# Humanetics Innovative Solutions, Inc.

Flesh Neoprene Corridor  
Flex PLI

IG GTR9-PH2 9<sup>th</sup> Meeting

# Comparison current and proposed corridor with results

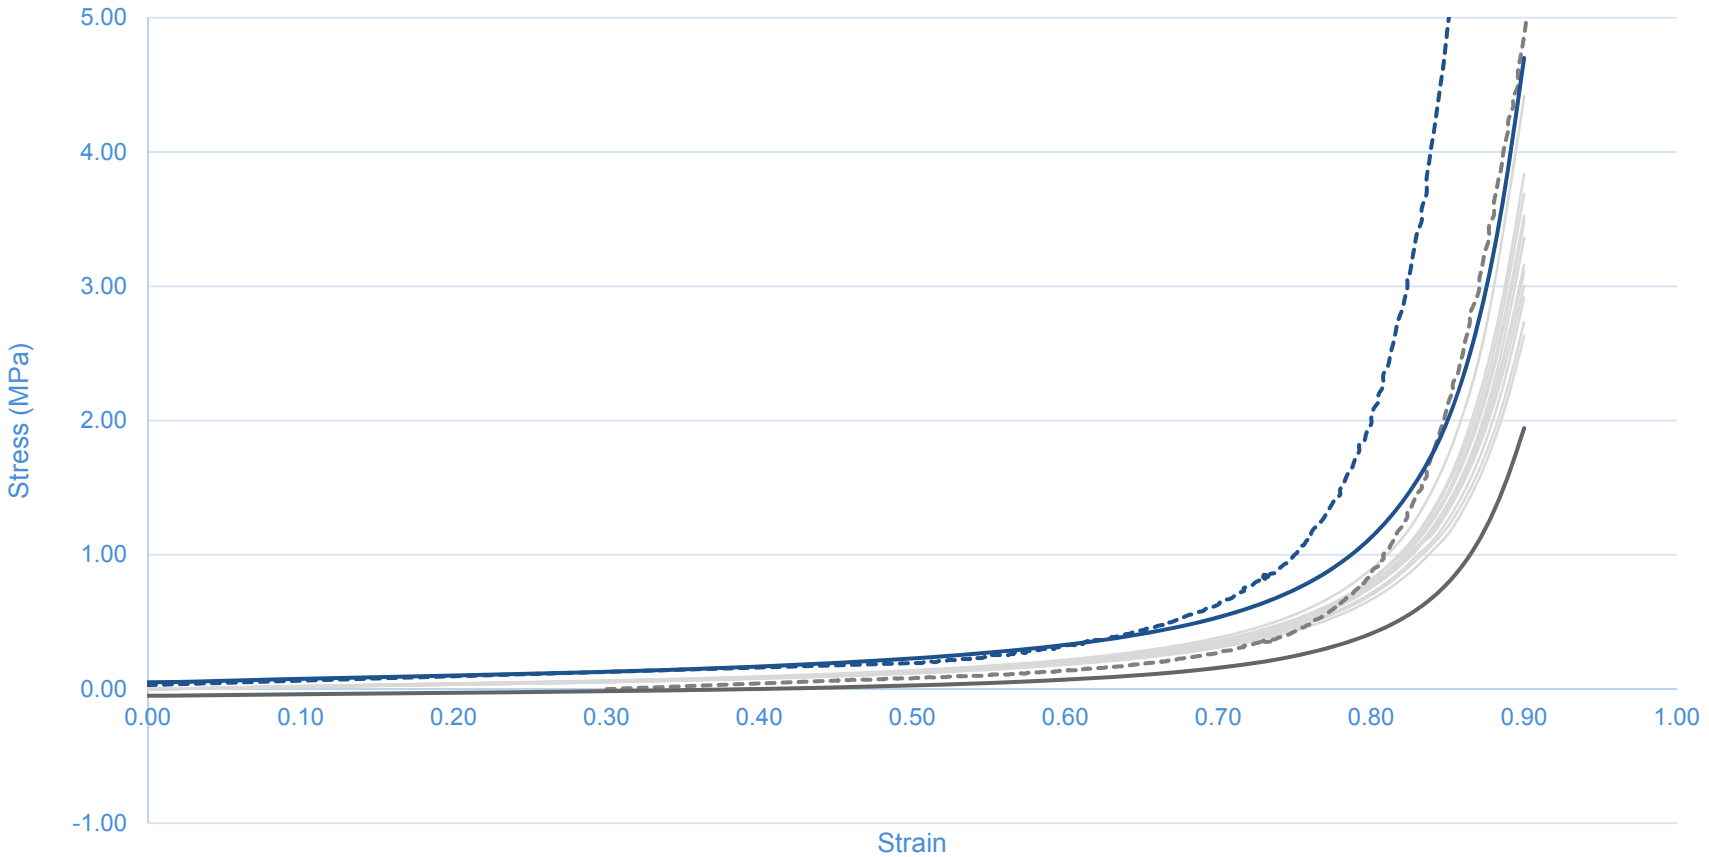
- ▶ The Neoprene corridor in the regulation does not match the GTR production specification (Dec 2008).
- ▶ This was due to a change in material and a difference in nominal thickness from 5 to 5.6 mm
- ▶ Testing 12 various samples 6 old and 6 new, results were used to redefine the stress strain requirement for the regulation
- ▶ Samples were compressed to 90% of their individual thickness

- ▶ Compression % was converted to strain
- ▶ The average of the 12 results were calculated
- ▶ A corridor of  $\pm 40\%$  on stress values was applied about the average
